ADDENDUM NO. 3
Waterfront Park Shoreline Improvements

Addendum 3: 05/01/2024

HARRISON TOWNSHIP
 WATERFRONT PARK
 SHORELINE IMPROVEMENTS
 SOIL EROSION AND SEDIMENTATION CONTROL PLAN

| SHEET C-5.0 | | |

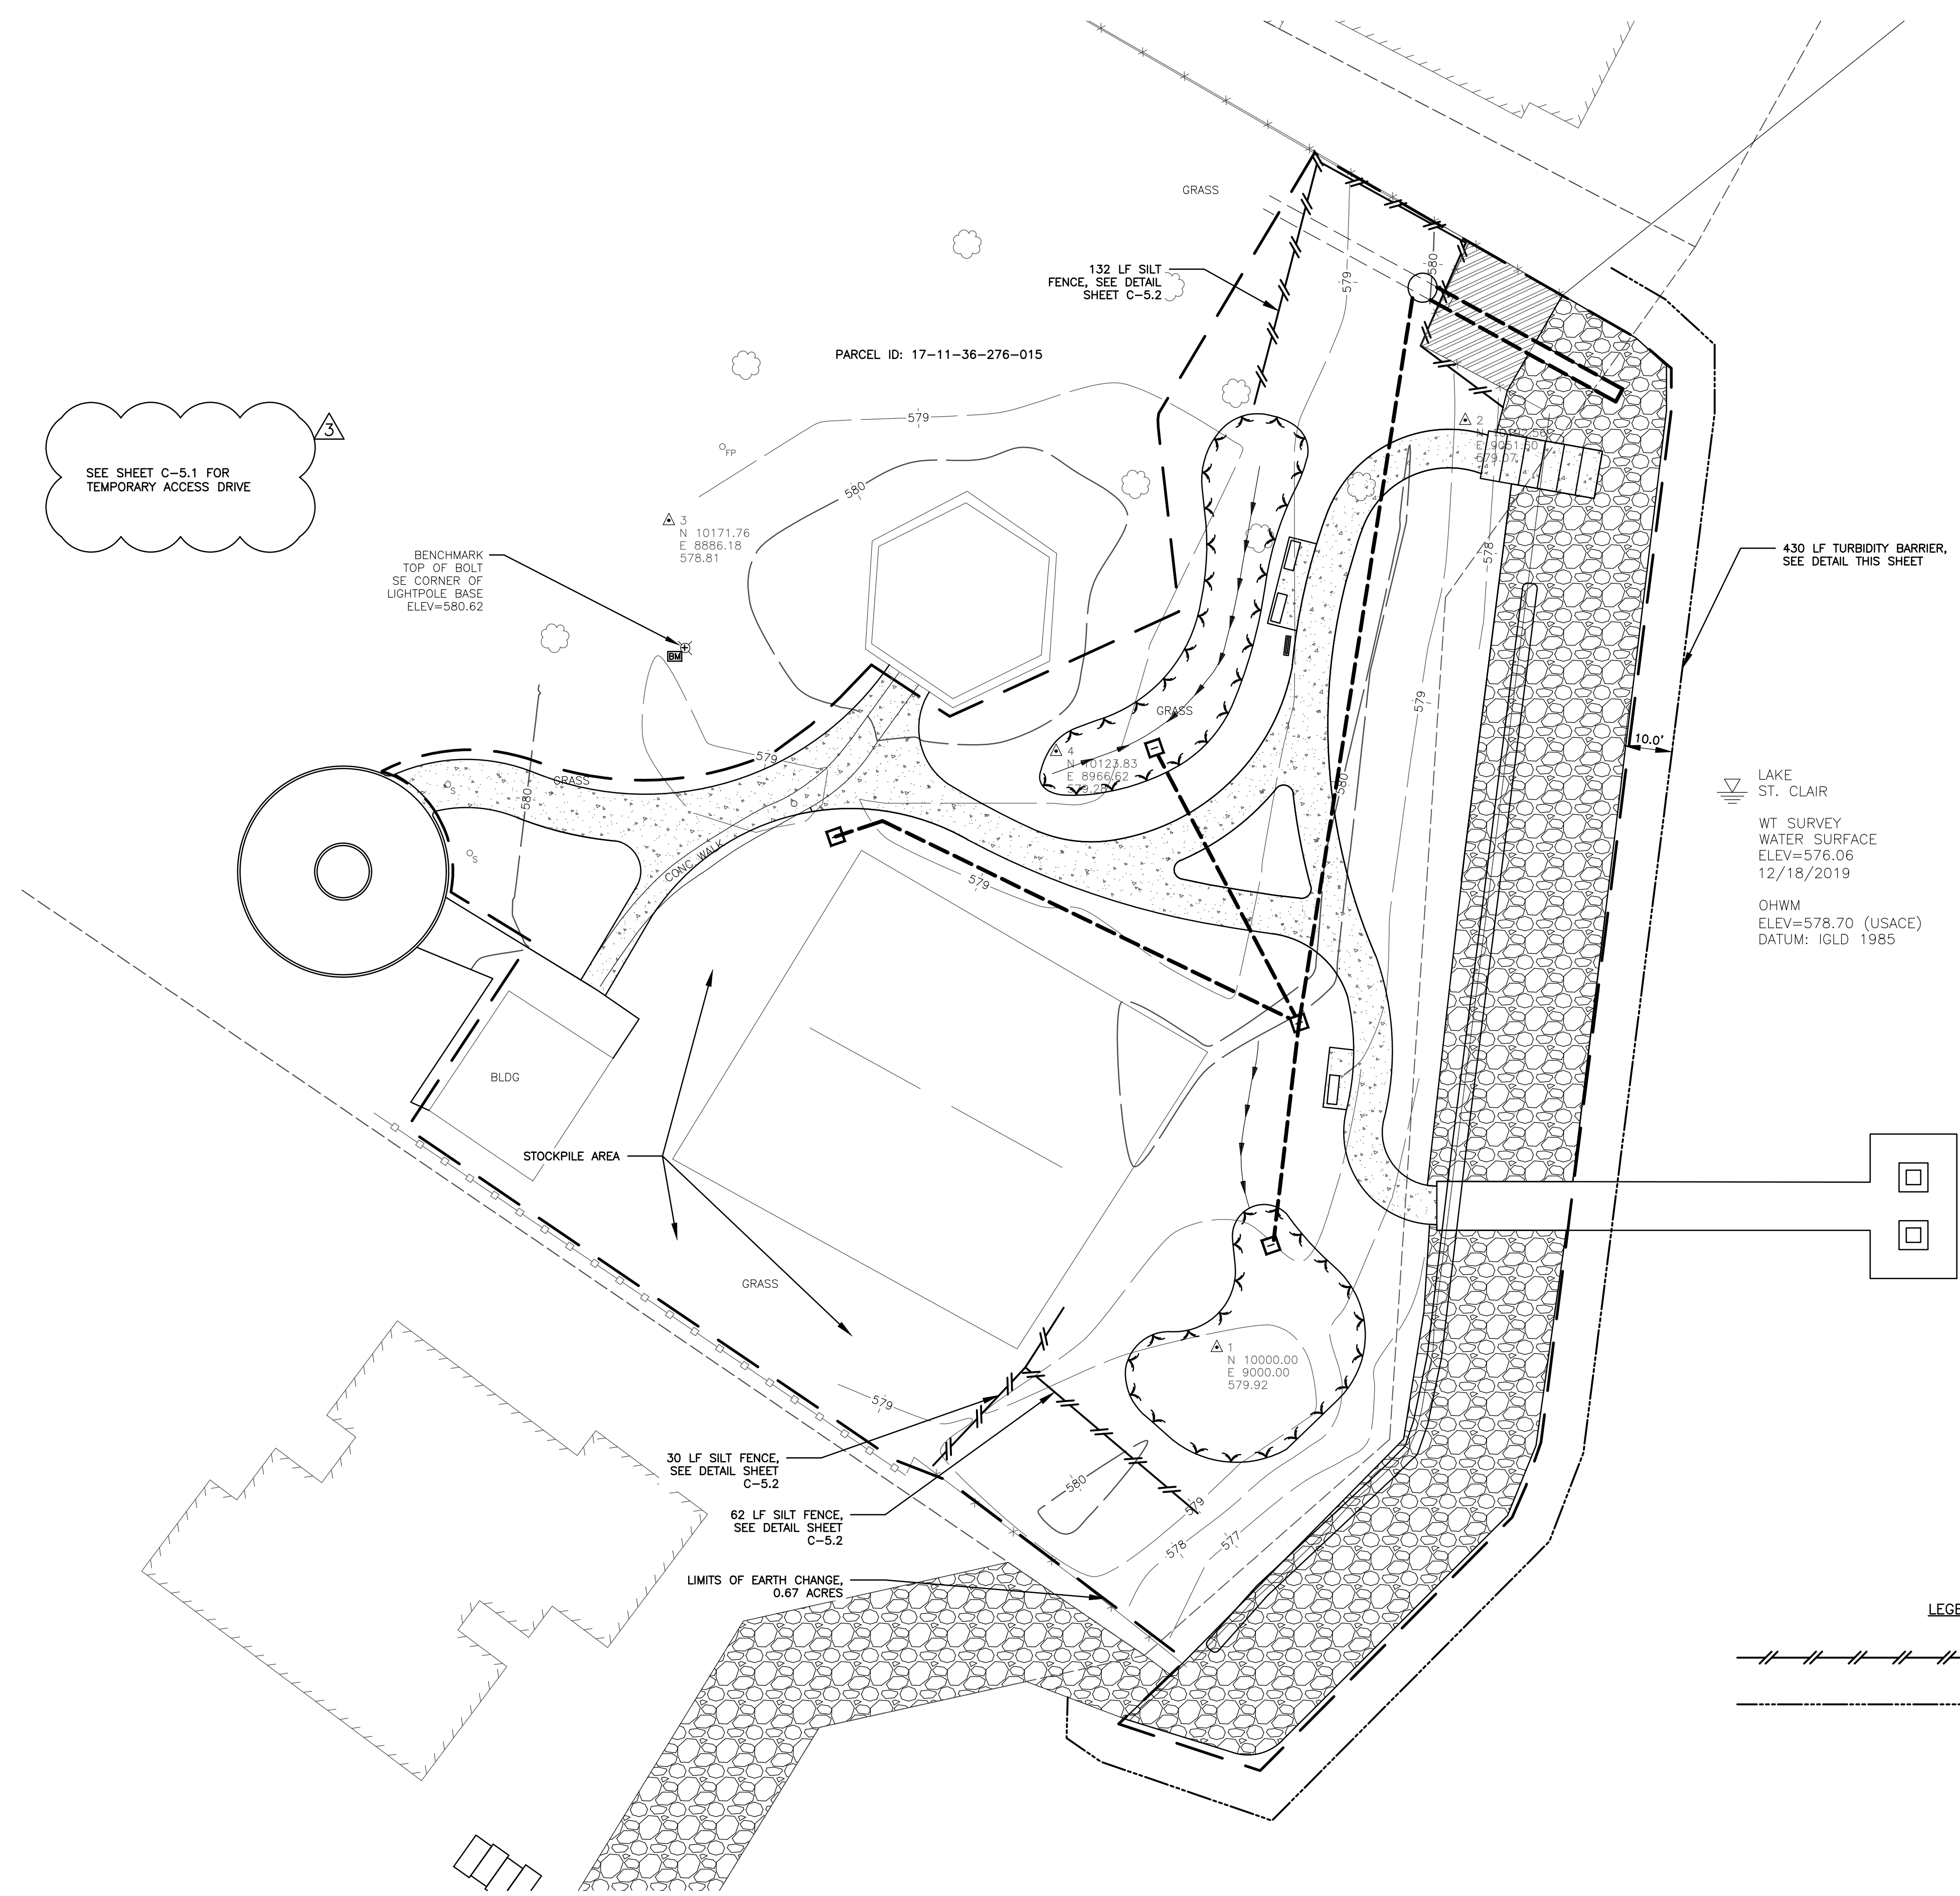
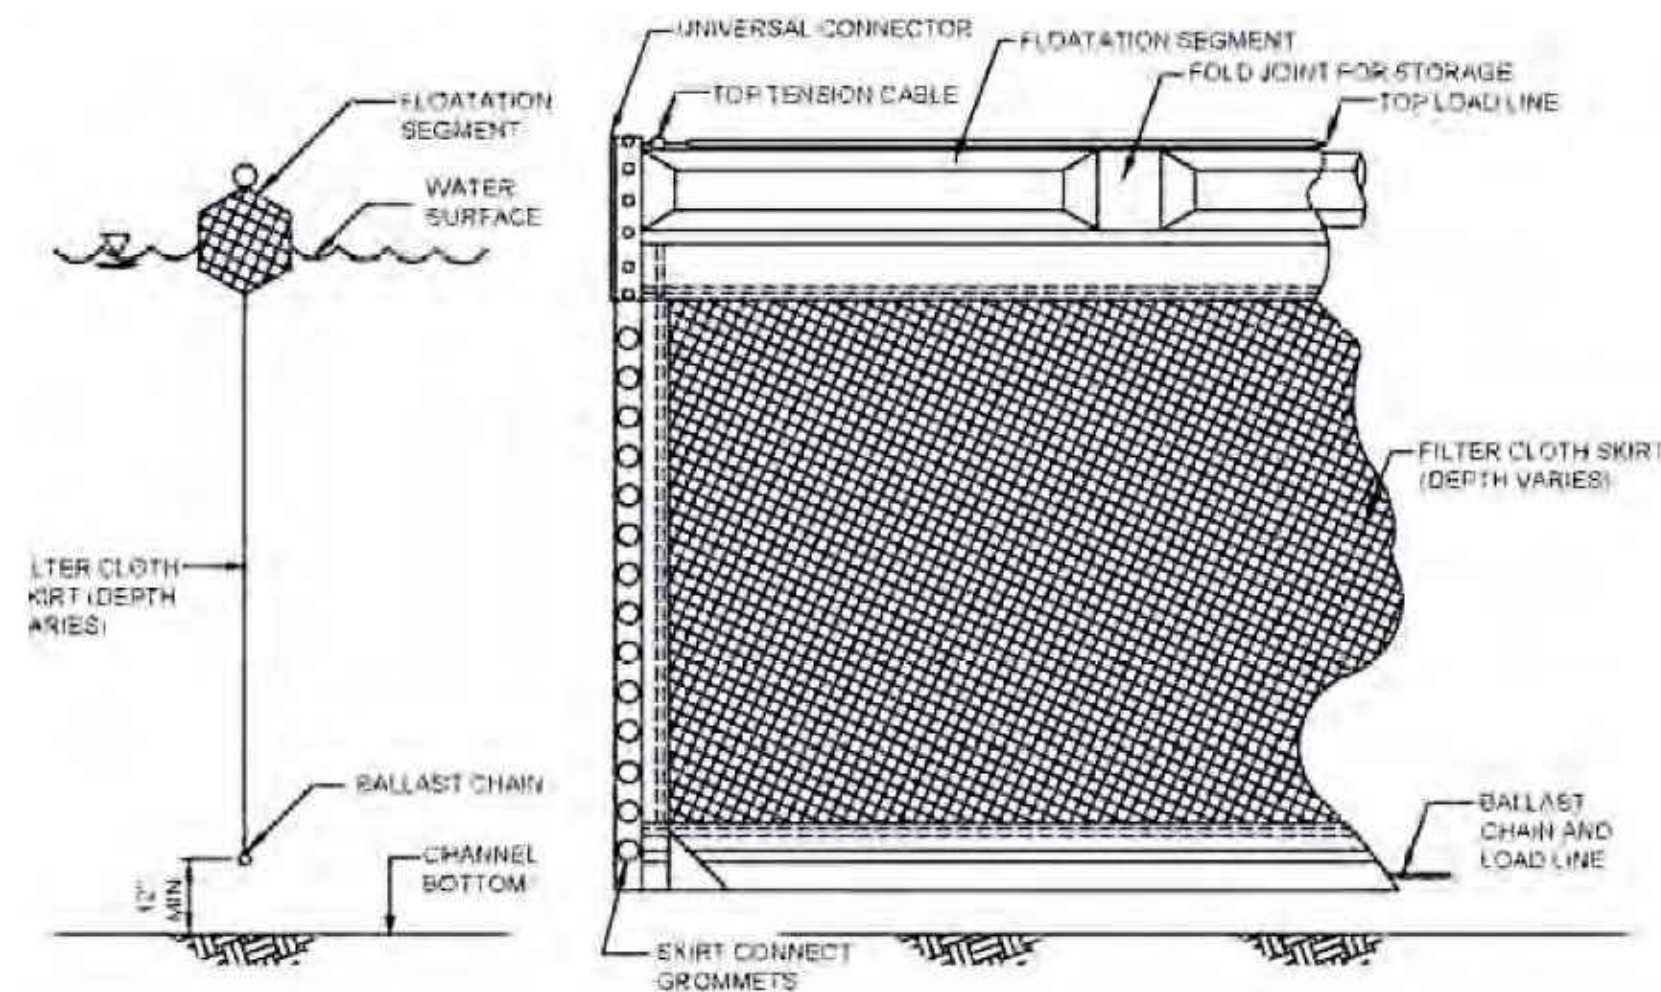
| Plan Sheet No. | Description of Change |
|-----------------------|---|
| Sheet C-5.0 | Previous design for gravel access drive has been removed and note has been added referring to C-5.1 for updated gravel access drive layout. |

| SHEET | C-5.1 | |

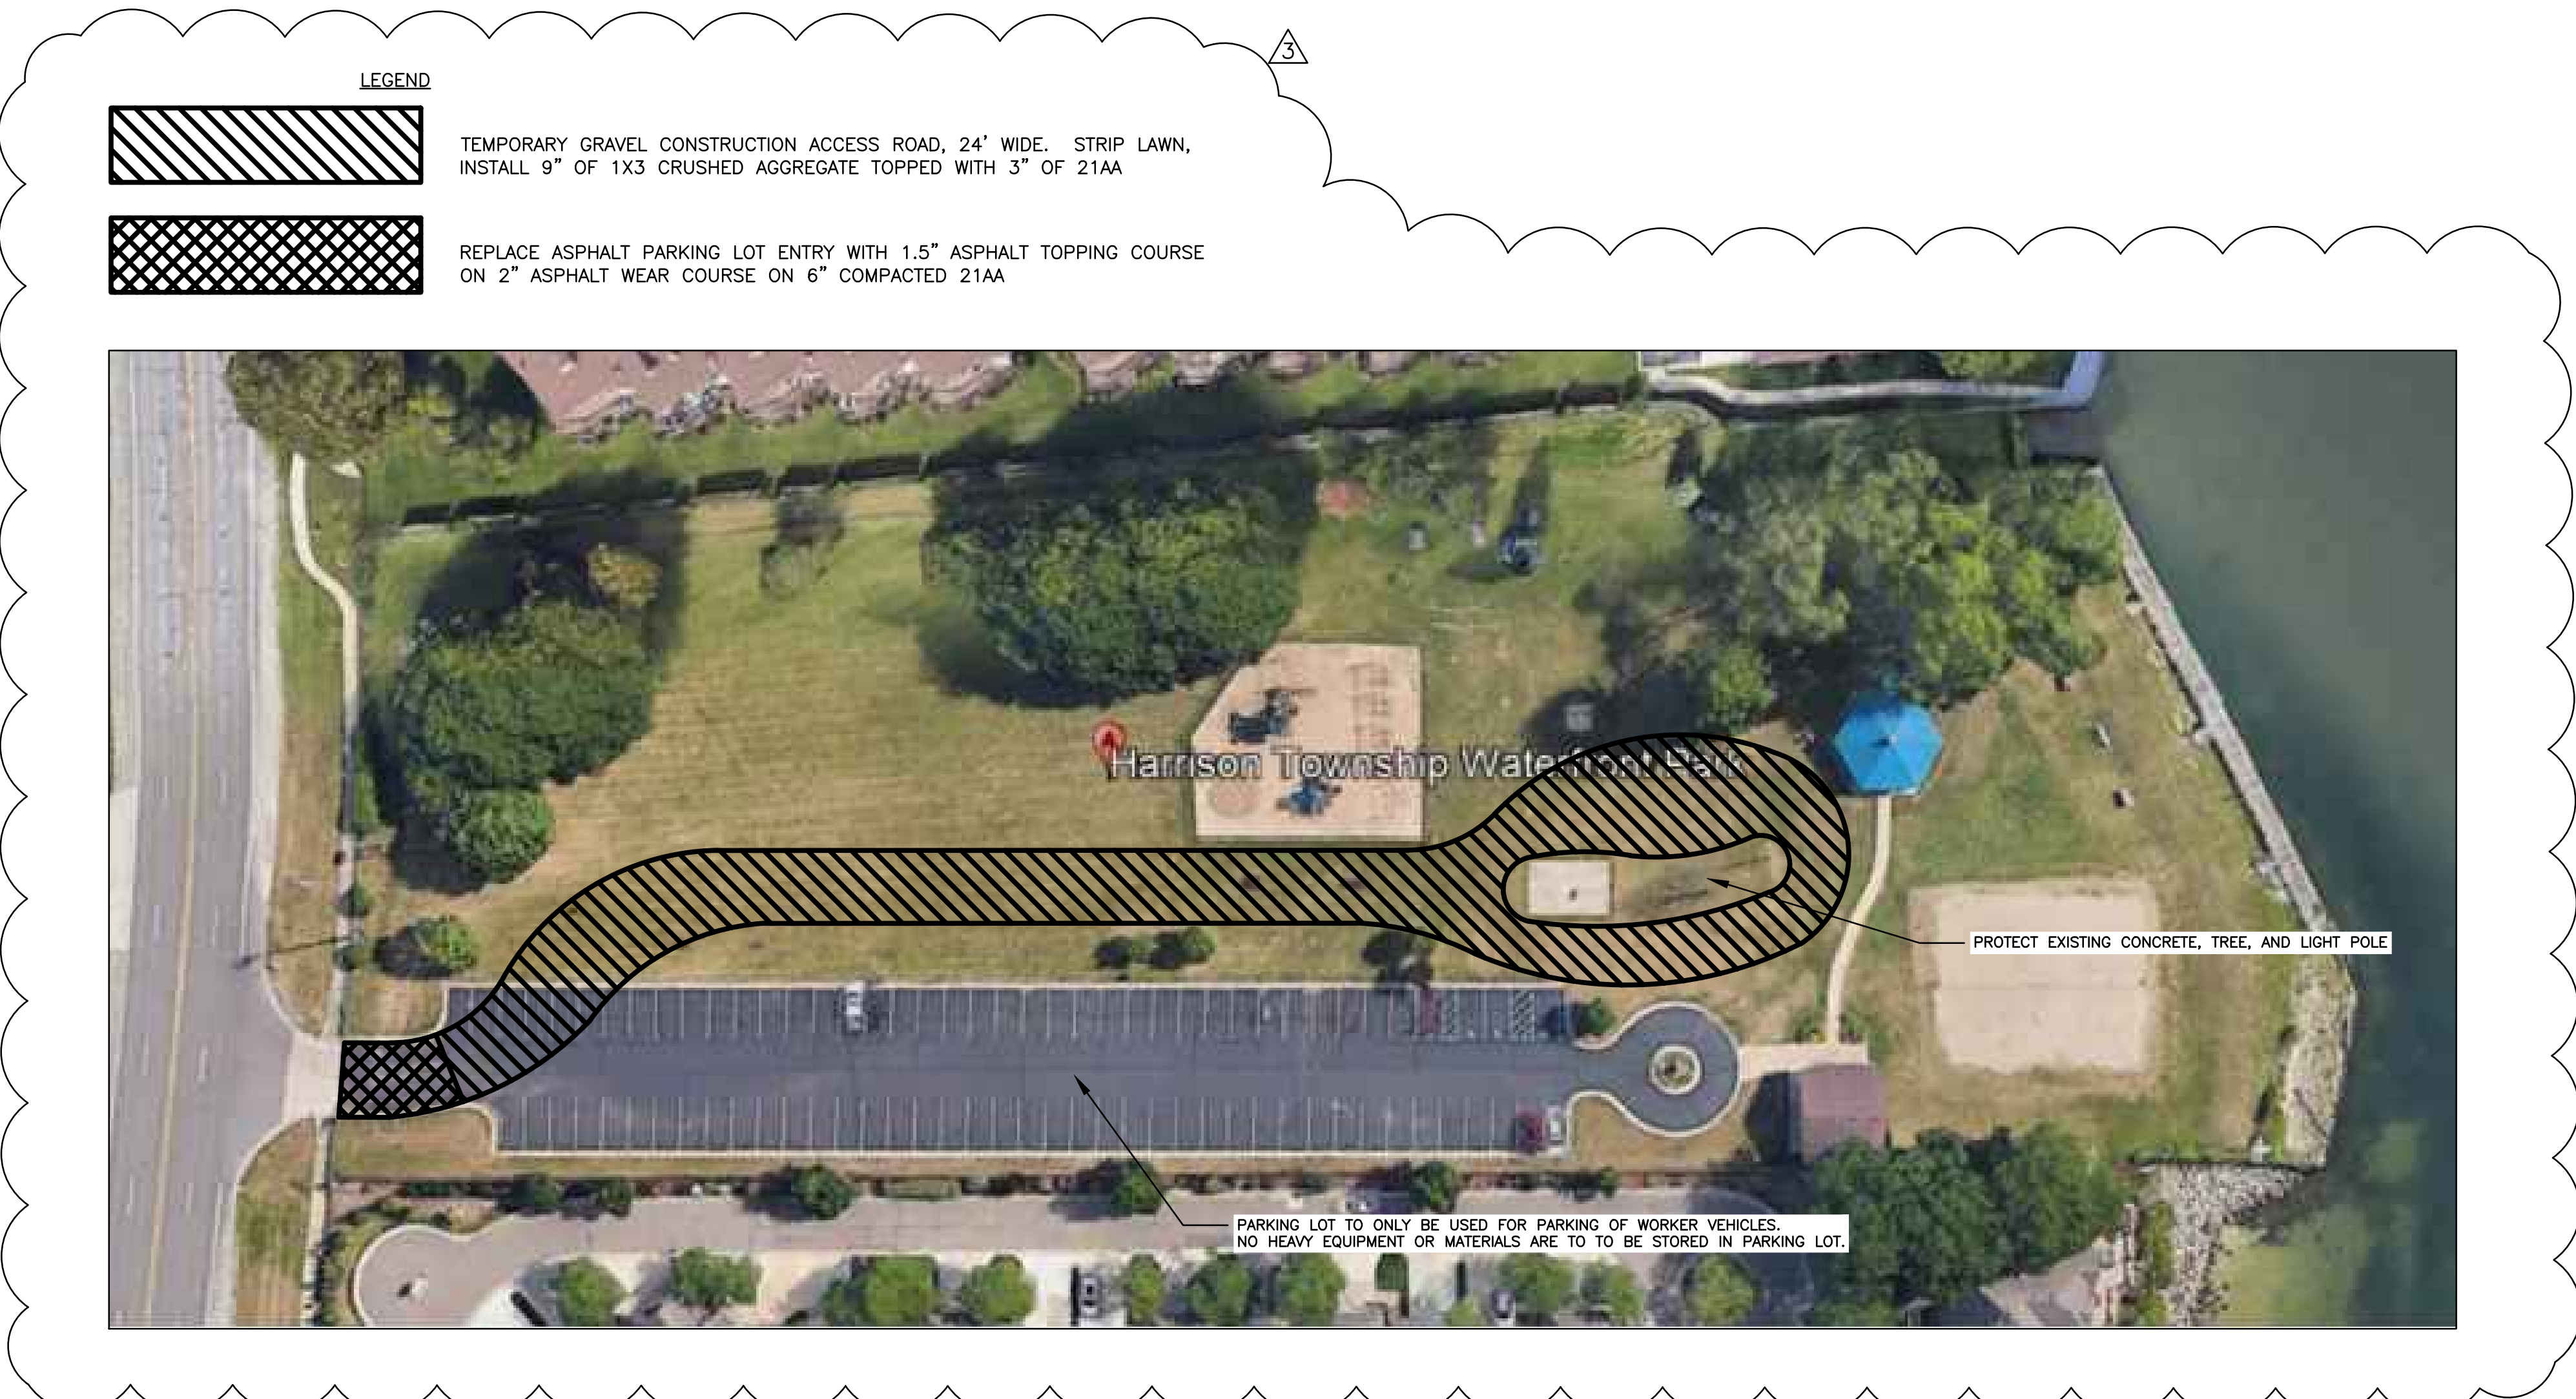
| Plan Sheet No. | Description of Change |
|-----------------------|---|
| Sheet C-5.1 | Temporary gravel construction access road and asphalt restoration have been added to SESC Legend and Notes sheet. |

- TEMPORARY GRAVEL CONSTRUCTION ACCESS ROAD, 24' WIDE. STRIP LAWN, INSTALL 9" OF 1X3 CRUSHED AGGREGATE TOPPED WITH 3" OF 21AA
- REPLACE ASPHALT PARKING LOT ENTRY WITH 1.5" ASPHALT TOPPING COURSE ON 2" ASPHALT WEAR COURSE ON 6" COMPACTED 21AA
